### 3 Presentation of officer reports

#### 3.1 48-52 Riversdale Road, Hawthorn - Four storey apartment building - PP23/0152

<b>Application Number</b>	PP23/0152
<b>Date Application Received</b>	08/03/2023
<b>Planning Officer</b>	Jock Farrow
<b>Applicant</b>	SP16 Pty Ltd
<b>Property Address</b>	48-52 Riversdale Road, Hawthorn
<b>Proposal</b>	Construct multiple dwellings on a lot and to create or alter access to a road in a Transport Zone 2; involving a 4 storey apartment building upon basement car parking
<b>Ward</b>	Riversdale
<b>Zoning</b>	Residential Growth Zone - Schedule 1 Adjoins Transport Zone 2
<b>Overlays</b>	None applicable
<b>Neighbourhood Character Precinct</b>	40
<b>Particular Provisions</b>	<ul style="list-style-type: none"> <li>• Clause 52.06 (Car Parking)</li> <li>• Clause 52.29 (Land Adjacent to the Principal Road Network)</li> <li>• Clause 53.18 (Stormwater Management in Urban Development)</li> <li>• Clause 55, including 55.07 (ResCode &amp; Apartment Developments)</li> </ul>
<b>Permit Triggers</b>	<ul style="list-style-type: none"> <li>• Clause 32.07-5 (RGZ) of the Boroondara Planning Scheme, a permit is required to Construct two or more dwellings on a lot.</li>

Figure 1: Extract North Elevation (TP-10) showing encroachment into B17 profile.

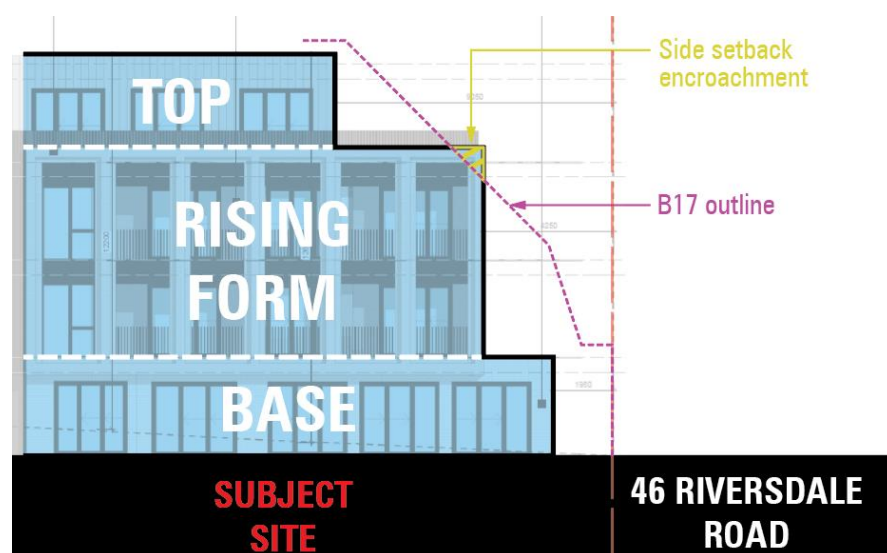
- Concern, however, is raised with the encroachment of APT 207 into B17, which will negatively impact up the amenity to the west.
- The Existing Conditions plan (TP-01) shows a 6.7m setback to the west (1/46 Riversdale Road) and a 7.6m setback to the east (60 Riversdale Road) resulting in a preferred front setback of 7.15m. In the absence of any clear justification for encroachment into the setback Standard B6, we recommend a minimum front setback of 7.15m be provided to the northern façade.

2. The split-level arrangement between the eastern and western portion of the building responds to the steep slope of the site allowing 4-storey massing without significant encroachment into the side setback, B17 profile. Section 1 (TP-12) of the architectural package does however reveal some encroachment which appears to be limited to the balcony balustrade of APT 206. We consider this minor encroachment to be acceptable however it appears the massing associated with APT 207 will have greater impact on the preferred neighbourhood character and will negatively impact amenity of current and future dwellings to the west. We also recognise it is difficult to assess adherence with Standard B17 given the stepped profile and sloped terrain along the western boundary. Therefore, we recommend an updated graphic be provided to demonstrate adherence with Standard B17 along the western boundary. While this will result in some 'trimming' to the top of Level 2, the design response must also consider the composition of the northern façade. A stepped or 'wedding cake' profile will not be considered acceptable.

Figure 2: Extract North Elevation (TP 101)

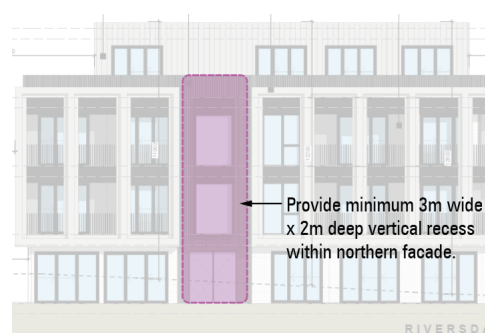
- c. Lastly, the overall length of balcony of 31m (15.5m per apartment) along the southern interface is considered excessive. The provision of a green 'break' with opportunities for planting

would offer welcome visual relief to neighbours (south) and future residents (APT G04 & APT G05).

Figure 3: Extract Ground Floor Plan (TP-05) showing potential adjustments to APT G04 and APT G05 open space and interface treatment.

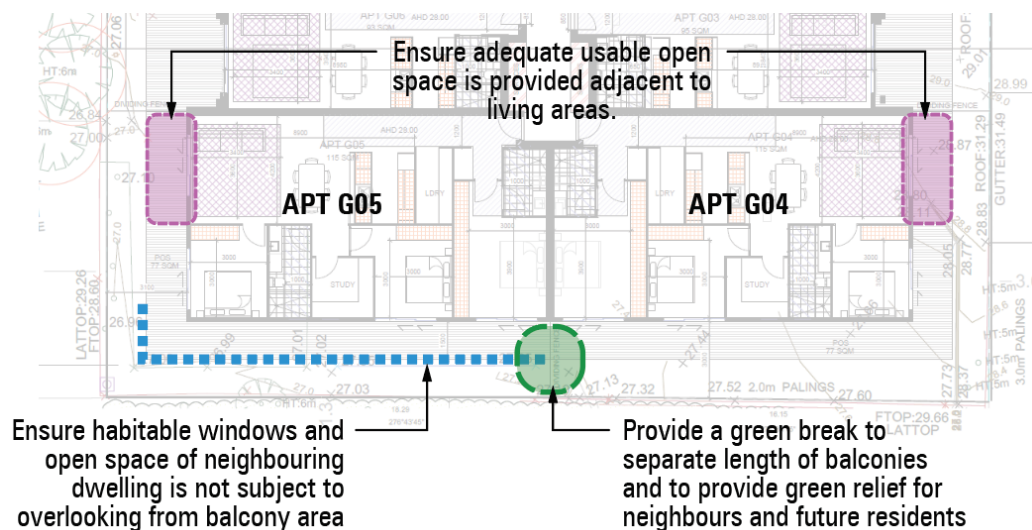
- b. Secondly, the maximum width of balconies shown for APT G04 & APT G05 is 1.5m which is 0.1m less than is required in Standard B28 (ResCode). While a 1.6m wide area adjacent to the living room would be acceptable, we consider 2.0m or more width to be desirable and commensurate with apartments of this size (3-bedrooms).

##### **Trees 8 and 9 - Subject site trees**

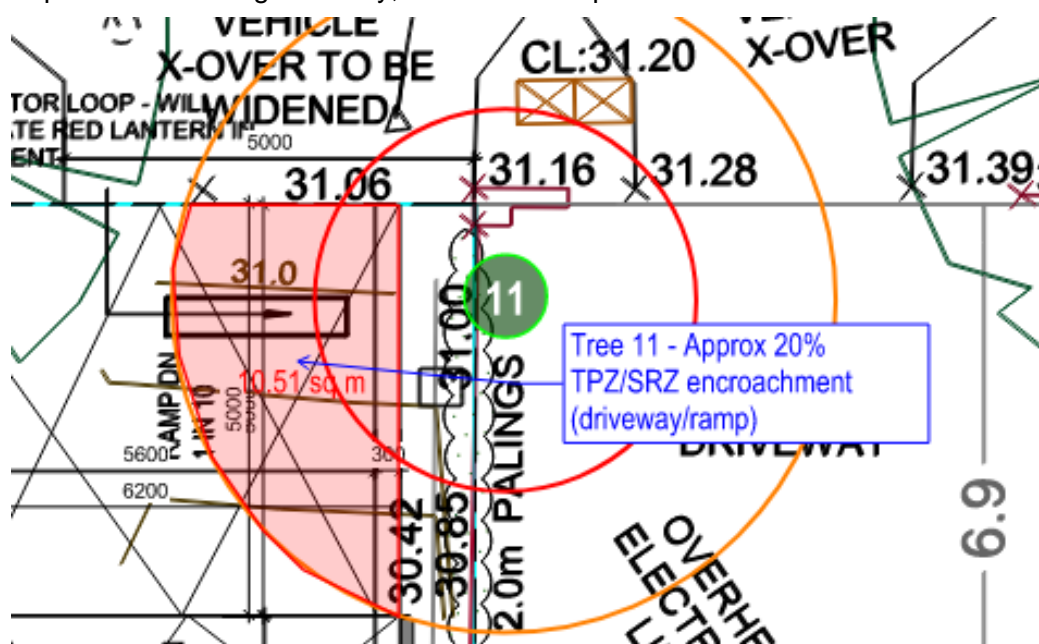
Likely self-seeded weed species tree with low amenity and streetscape value. Their removal would be supported with replacement planting. Local law permits do not appear to be required for their removal.

#### **Tree 14 - Subject site vegetation**

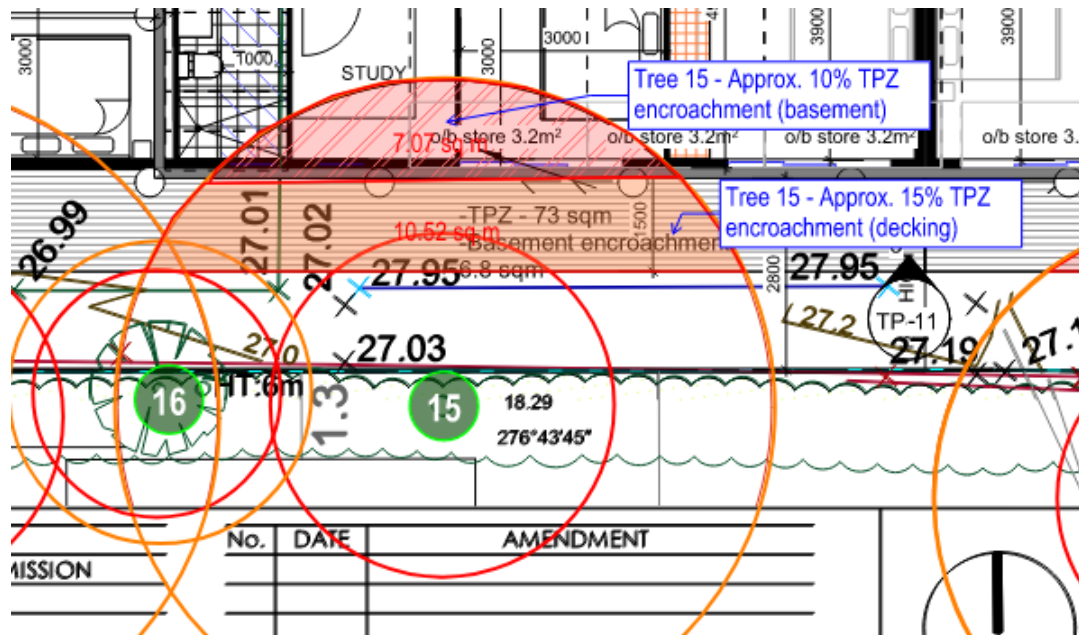
Hedging trees which have been identified as low amenity and poor structure. Their removal would be supported and would have minor impacts on the treed character of the neighbourhood. These trees appear to be under permit size based on the arborist report.

Tree 17 - Proposed TPZ encroachment (dwelling/decking)

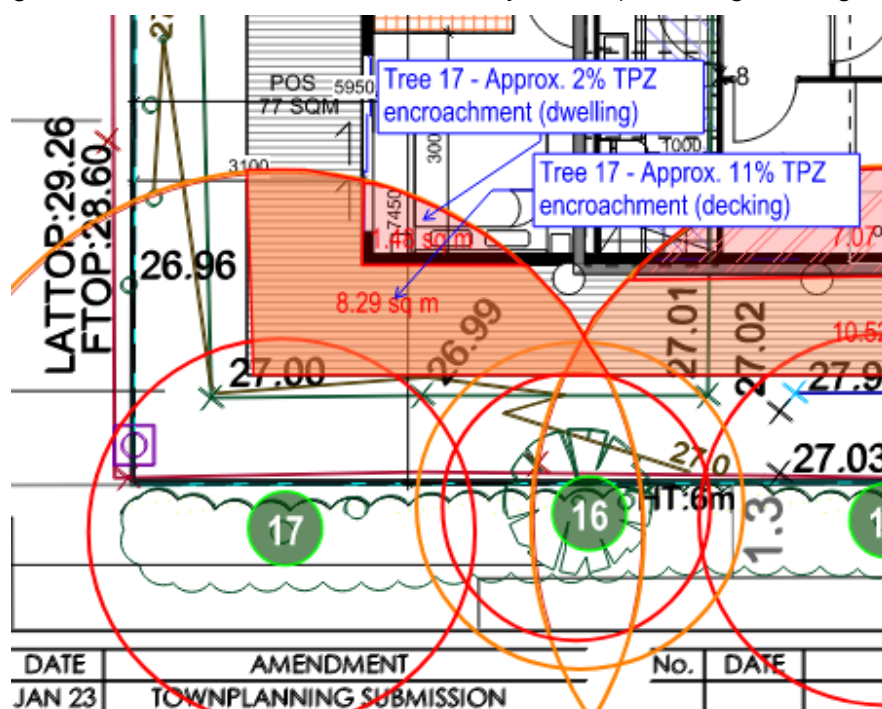
The proposed dwelling represents a TPZ encroachment of approx. 2% which is considered minor and unlikely to impact the tree. The proposed decking represents a further TPZ/SRZ encroachment of approx. 11%. Although the combined encroachment is marginally over what is considered minor, the proposed works are unlikely to impact the tree. The decking must be constructed above grade utilising root sensitive footings. Decking to be deleted within the SRZ. The TPZ area must be maintained at existing grade where it encroaches into the subject site (excluding building footprint).

Figure 3 - Second floor setbacks from the southern boundary

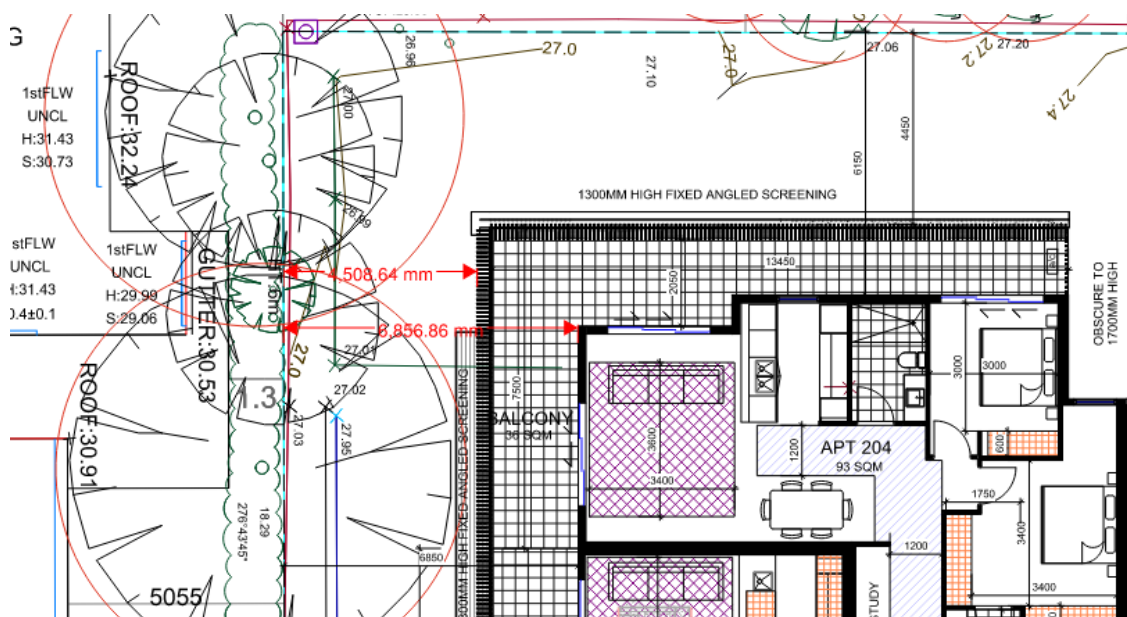
At second floor level to the balustrade/screening of the balcony, a height of 8.65m is proposed which requires a setback of 4.73m; a setback of 4.5m is proposed which falls short of the standard. The shortfall relates only to the overhanging component of the overlooking screening; it is therefore recommended to require compliance with the standard by way of a condition on any permit that issues.

To the second floor wall, it has a height of 10.5m which requires a setback of 6.58m; a setback of 6.85m is proposed which complies.

Figure 4 - Sectional diagram demonstrating overlooking measures from second floor terrace, toward the rear

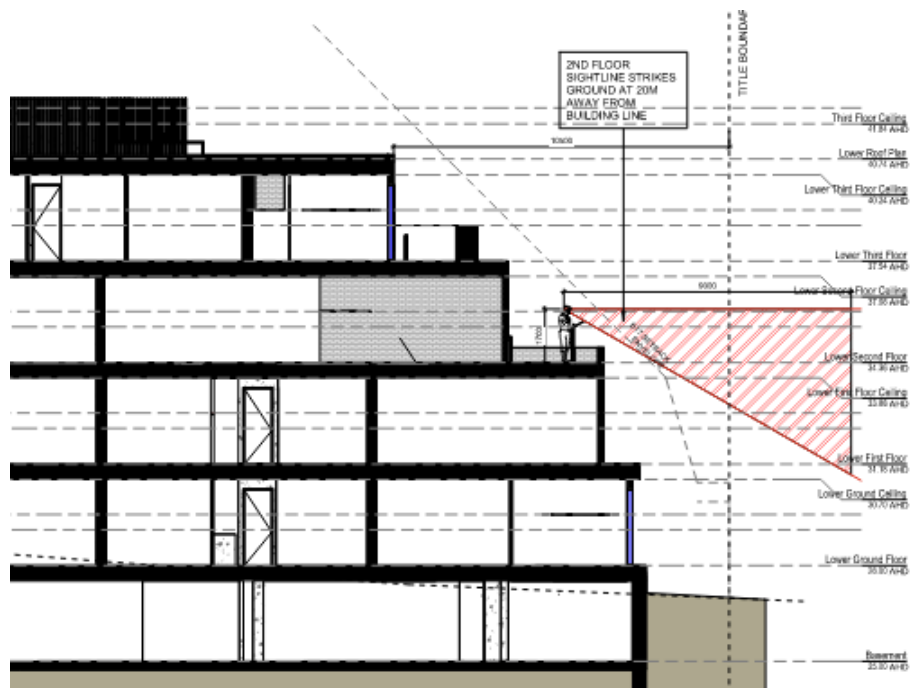
To the rear, overlooking is addressed through the use of 1.7m high screening at first floor.

At second floor, the use of a 1.3m high angled balustrade is proposed. Overlooking diagrams demonstrate that there would be no undue overlooking to neighbouring SPOS areas. However, it appears that overlooking would occur to the neighbouring north facing window (within 3m of the common boundary). It is considered that this issue could be addressed by a permit condition.

Figure 5 - Sectional diagram demonstrating overlooking measures from second floor terrace, toward the west

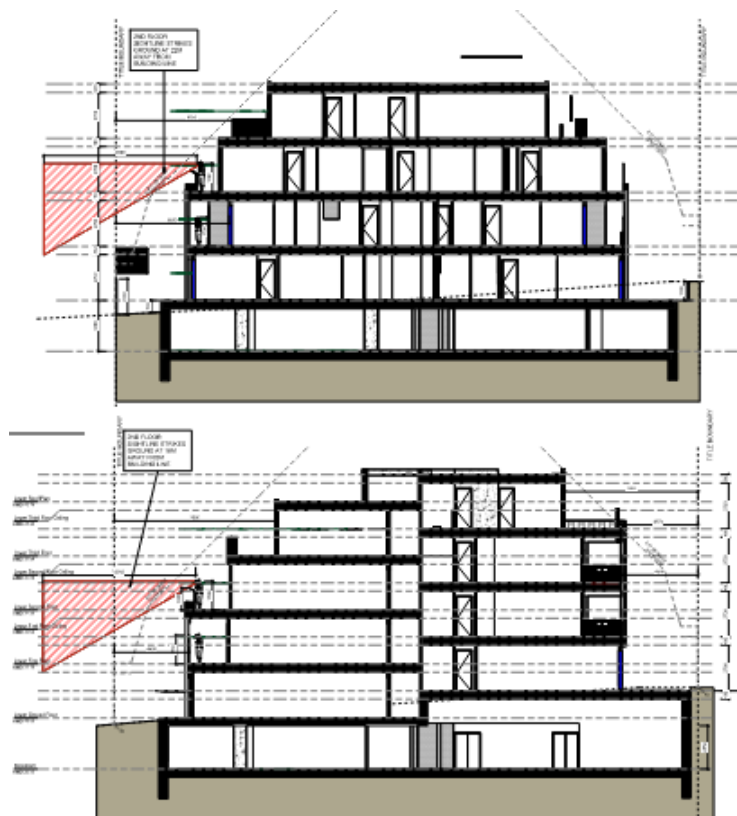
At first floor and part of the second floor, overlooking is addressed through the use of 1.7m high screening and obscure glazing.

To the balance of the second floor, the use of a 1.3m high angled balustrade is proposed. As with the rear elevation, overlooking diagrams demonstrate that there would be no undue overlooking to neighbouring SPOS areas; however, it appears that there would be overlooking to neighbouring windows. It is considered that this issue could be addressed by a permit condition.
